ADDENDUM 4

ITB TDD 45-19

Security Office Remodeling, Audio-Visual System and Electronic Safety and Security Systems
for Convention Center and Welcome Center

Date of Issue: May 22, 2019

A401
As indicated

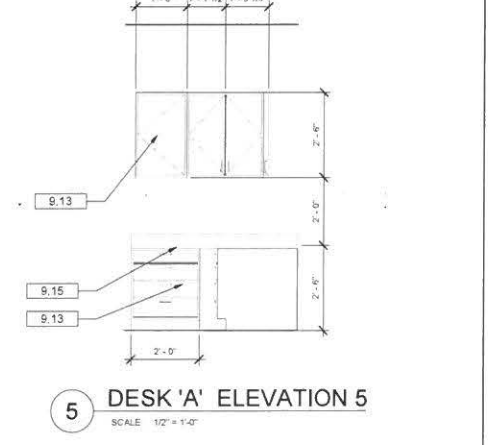
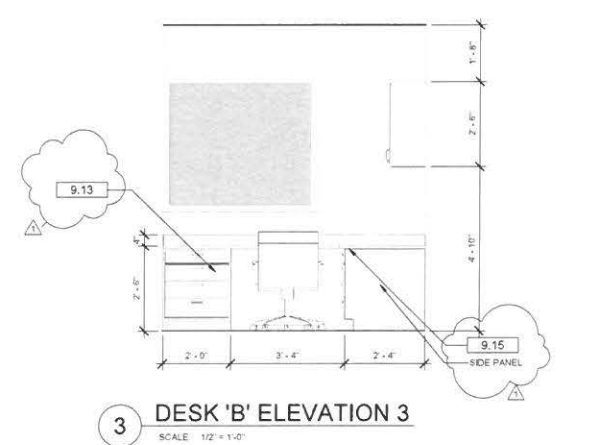
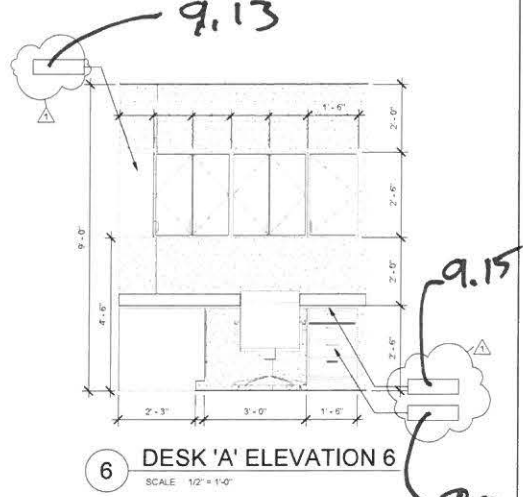
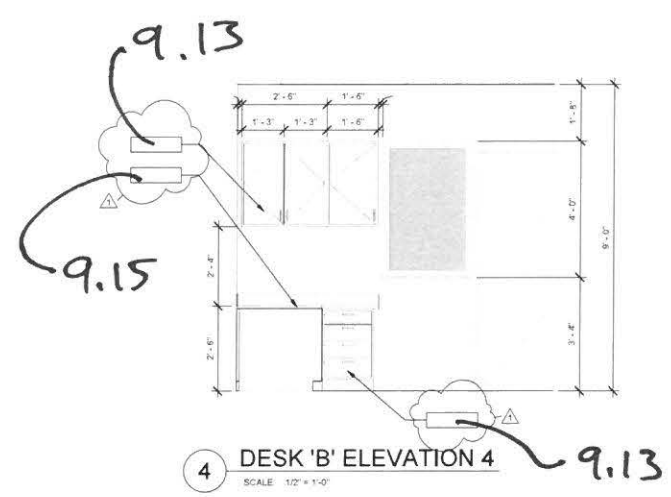
- Sheet A401 is attached with the following changes:
 - Deleted General Note #1 which referenced Sheet A400 which is not part of the bid set
 - Blank Keynote references on Desk Elevations were corrected.
